2. REF. AGUSTA T/N: 3G6205G03731.

TRIM TAB BENDING GAUGE ASSY.

RBW6205G03731-3G /IAT'L DRAWN BY: CLOUGH UNLESS OTHERWISE SPECIFIED
DIMENSIONS ARE IN INCHES
.XXX ± .005 FRACTIONS ± 1/8
.XX ± .01 ANGLES ± .5°
.X ± .1 FINISH
.X ± .1 SPECIFICATIONS TRACTIONS TRACT OR .015 x 45°
OR .015 R
2. DIMENSIONAL LIMITS APPLY AFTER PLATING USED ON MODEL AGUSTA AW139 SCALE 2/2/2011 SHEET 1 OF 9 1:4

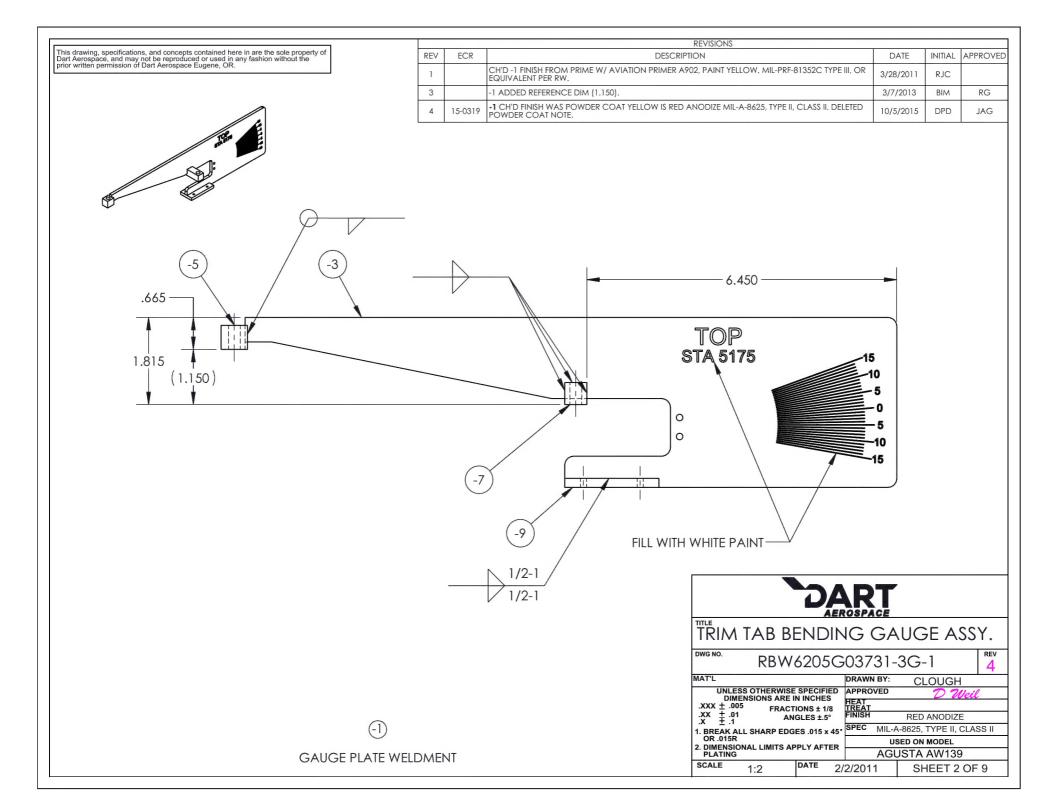
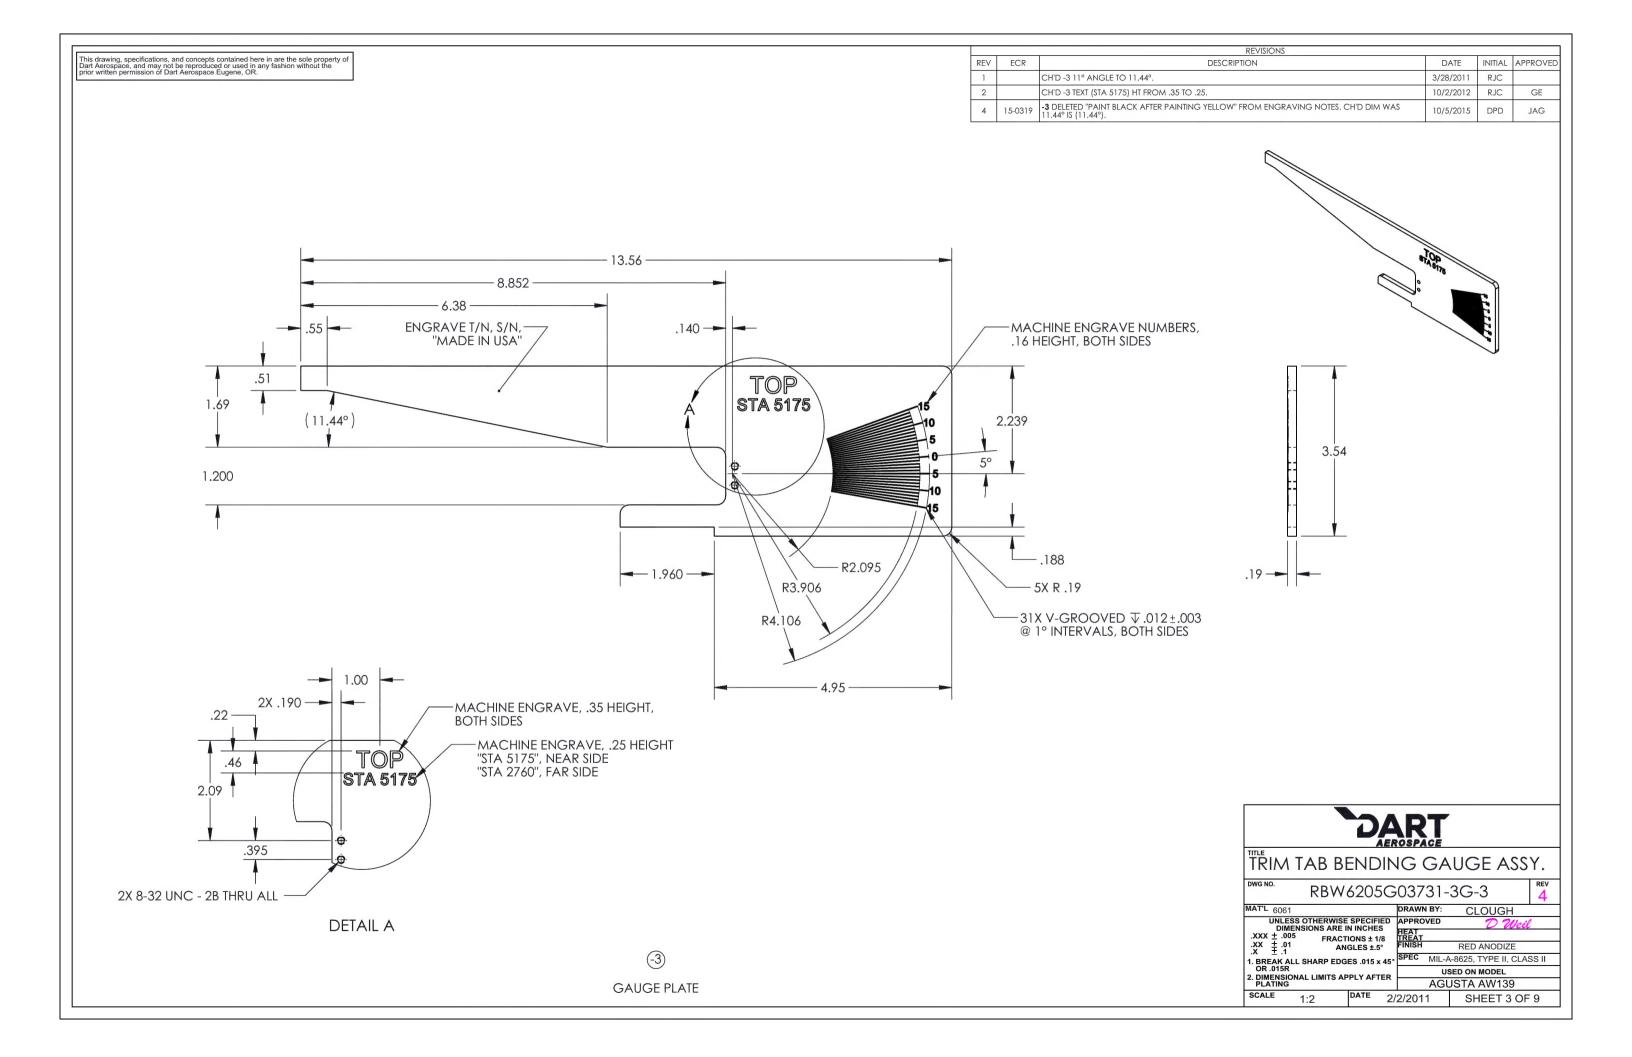
REVISIONS							
REV	ECR	DESCRIPTION	DATE	INITIAL	APPROVED		
1		CH'D BOM -15 FROM 5/8 LENGTH, ADDED BOM -23 & -25, CH'D -1 FINISH FOM PRIME W/ AVIATION PRIMER A902, PAINT YELLOW, MIL-PRF-81352C TYPE III, OR EQUIVALENT PER RW. CH'D -3 11° ANGLE TO 11.44°, CH'D -5 & -7 HOLE FROM DIAMETER. 238 & -5 HOLE TO THRU HOLE, ADDED MISSING DIM'S -1 6.450 & -5 .050, CH'D -15 DESIGN DIM'S PER GE.	3/28/2011	RJC			
2		Ch'd -3 text (sta 5175) ht from .35 to .25 added -5 missing dimensions .275 & .230, Ch'd S.F 16 to -3. Ch'd -7 slot depth from .135 to .125, and S.F16 to -3.	10/2/2012	RJC			
3		-1 ADDED REFERENCE DIM (1,150)13 CH'D DIM WAS Ø.180 C-SINK .09 X 82°(X2) IS Ø.180 THRU C- SINK Ø.360 X 82° (X2).	3/7/2013	BIM	RG		
4	15-0319	UPDATED TO NEW DRAFTING STANDARDS1 CH'D FINISH WAS POWDER COAT YELLOW IS RED ANODIZE MIL-A-8625, TYPE II, CLASS II, DELETED POWDER COAT NOTE, -3 DELETED "PAINT BLACK AFTER PAINTING YELLOW" FROM ENGRAVING NOTES, CH'D DIM WAS 11,44° IS (11,44°), -11 DELETED DIMS 5.70, (3,935), CH'D DIMS WAS R.50 IS R.46, WAS 7.00 IS 6.967, ADDED DIM R.13, CH'D TOLERANCE ON NON-CRITICAL DIMENSIONS,	10/5/2015	DPD	JAG

END BEARING MOUNT

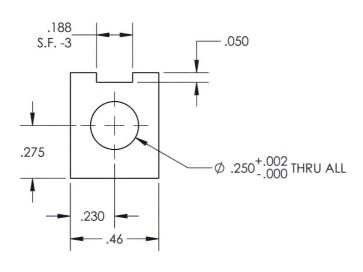
revisions						
REV	ECR	DESCRIPTION	DATE	INITIAL	APPROVED		
1		CH'D -5 HOLE FROM DIAMETER .238 & HOLE TO THRU HOLE. ADDED MISSING DIM .050.	3/28/2011	RJC			
2		ADDED -5 MISSING DIMENSIONS .275 & .230, CH'D S.F16 TO -3.	10/2/2012	RJC	GE

DBL. BEARING MOUNT

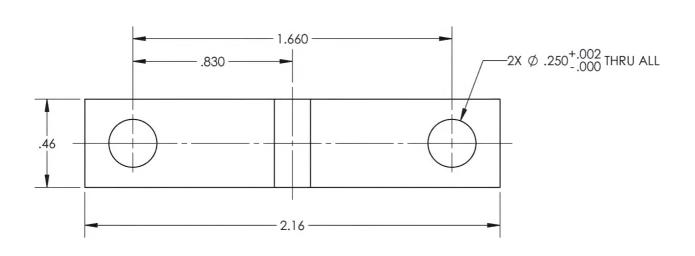
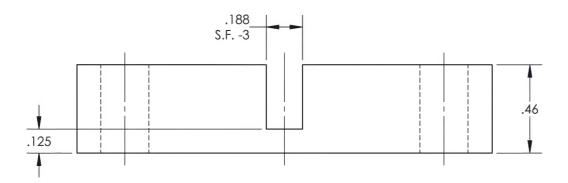
REVISIONS .							
REV	ECR	DESCRIPTION	DATE	INITIAL	APPROVED			
1		CH'D -7 HOLE FROM DIAMETER .238.	3/28/2011	RJC				
2		CH'D -7 SLOT DEPTH FROM ,135 TO ,125, AND S.F16 TO -3.	10/2/2012	RJC	GE

SPRING

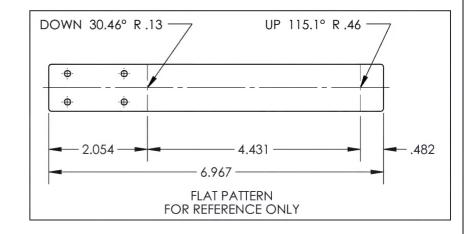
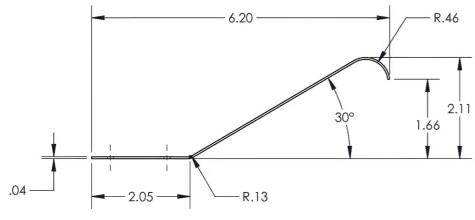
REVISIONS								
REV	ECR	DESCRIPTION	DATE	INITIAL	APPROVED				
4	15-0319	-11 DELETED DIMS 5.70, (3.935). CH'D DIMS WAS R.50 IS R.46, WAS 7.00 IS 6.967. ADDED DIM R.13	10/5/2015	DPD	JAG

STOP

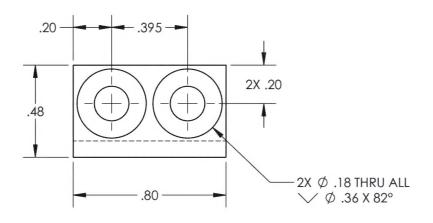
revisions							
REV	ECR	DESCRIPTION	DATE	INITIAL	APPROVED			
3		-13 CH'D DIM WAS Ø.180 C-SINK .09 X 82°(X2) IS Ø.180 THRU C-SINK Ø.360 X 82°(X2).	3/12/2013	BIM	SE

BEARING

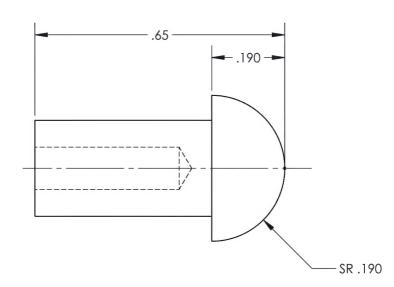
revisions							
REV	ECR	DESCRIPTION	DATE	INITIAL	APPROVED			
1		CH'D -15 DESIGN DIMS PER GE.	3/28/2011	RJC
